Service Bulletin

S.B. No: 92

- Title:** INSPECTION AND RECTIFICATION OF FUEL VENT AND HYDRAULIC RESERVOIR TUBE, PLUS VENT PIPE INLET RE-ORIENTATION
- Classification:** This Service Bulletin has been classified by SAL as Highly Recommended.
- Compliance:** This is a one time inspection, at or before next fifty hour check.
- Applicability:** Actions 1, 2.1 and 3 applicable to T67M260-T3A only. Works No. 2109, 2110, 2123 to 2128, 2130 to 2158, 2160 to 2233.
- Action 2.2 applicable to, T67C wing tank (Post Mod M156) only, T67M-MkII, T67M200 and T67M260.

This Issue 2 introduces an inspection of the vent for the T67C wing tank (Post Mod M156) only, T67M-MkII, T67M200 and T67M260. The original T67M260-T3A information is retained for record only.

FIGURE 1

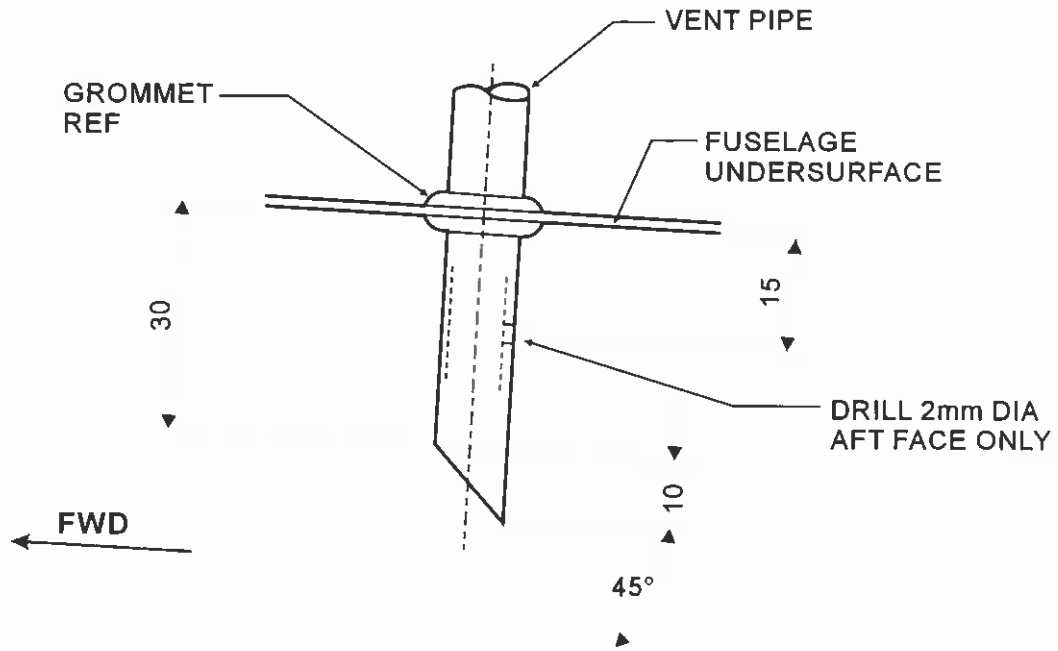
During the course of this inspection, ref. T67M260-T3A, ensure the vent pipe inlets are facing forward ref. Figure 1. The pipes are to be re-orientated through 180° to minimise the possibility of fuel in the vent line draining from the aircraft during flight. This action invokes a modification, Mod M701.

- 2.1 **T67M260-T3A only.** During inspection or during course of replacement, re-fit vent tubes with opening facing forward. Drill 2mm diameter hole in aft face. Ref. Figure 1.

- 2.2 T67C wing tank (Post Mod M156) only, T67M-MkII, T67M200 and T67M260. Inspect the fuel vent pipe for correct orientation and configuration, ref. Figure 1. If incorrect, re-assemble as shown. If necessary fit new item (SAL Stock Code 126-36-002, length 230mm), to the configuration shown in Figure 1, ensuring vent tubes opening faces forward and 2mm diameter hole is in aft face.

This action invokes Modification M701. Annotate in aircraft logbook "Mod M701 incorporated.

This action invokes Modification M701. Annotate in aircraft logbook "Mod M701 incorporated if applicable.
